QUESTIONS AND ANSWERS

IFB #02092024VK - FORD RD ES ANNEX FLOOR

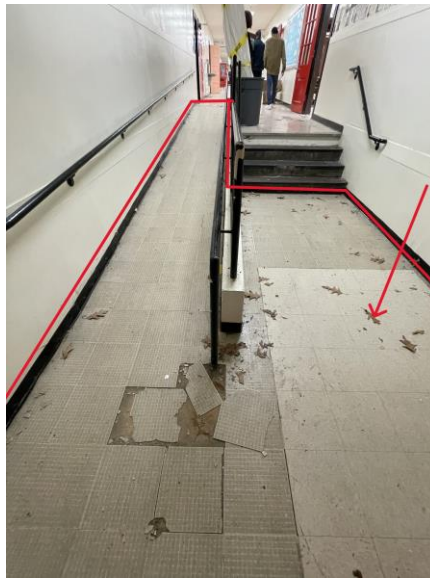
6. Related to Server room quipment.

Please refer to the photo below – the server rack is floor mounted, so do we need to cut around it and replace it with the new floor tile (or) do we need to completely remove the rack and replace the whole area?

ANSWER: Leave server rack in place and cut around it.

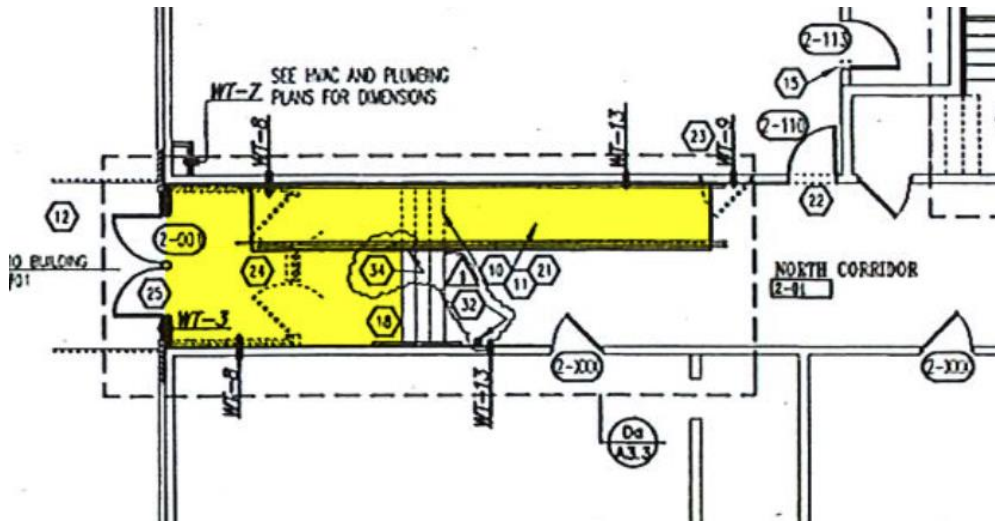
7. Related to Tiles on the ADA Ramp and at the north entrance hall. Please refer to the below screenshot and the site photo.

- a. For the ramp we need to remove just the Anti-Skid tiles and replace them with new tile which means no demo of the plywood or sub-floor beneath the ramp area.

- b. The whole yellow highlighted area needs to be replaced with Anti-skid tiles (or) it is only limited to the ramp area.

ANSWER: Yes, put back Anti-Skid tiles in that area.

ANSWER: Just, the ramp area.

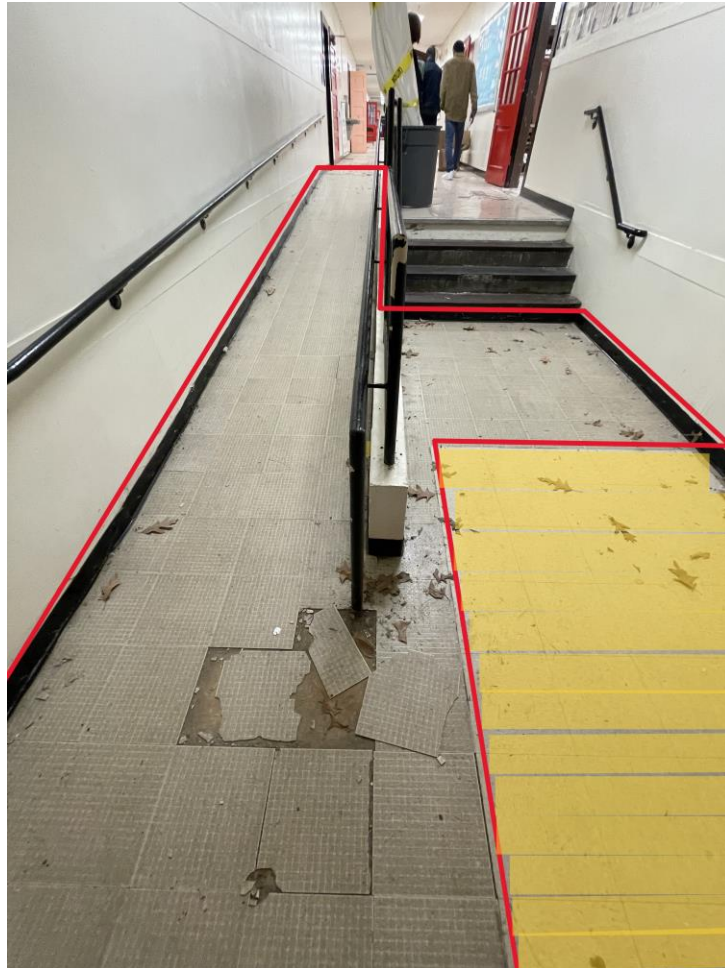
- c. Please refer to the below site photo. As per existing conditions, the area marked in red is completely Anti-Skid tiles, and yellow highlight is the VCT. Do we need to match the existing pattern while replacing the new flooring (or) can the complete area be Anti-skid tiles?

ANSWER: Just, the ramp area. New Anti-Skid rubber treads on stairs.
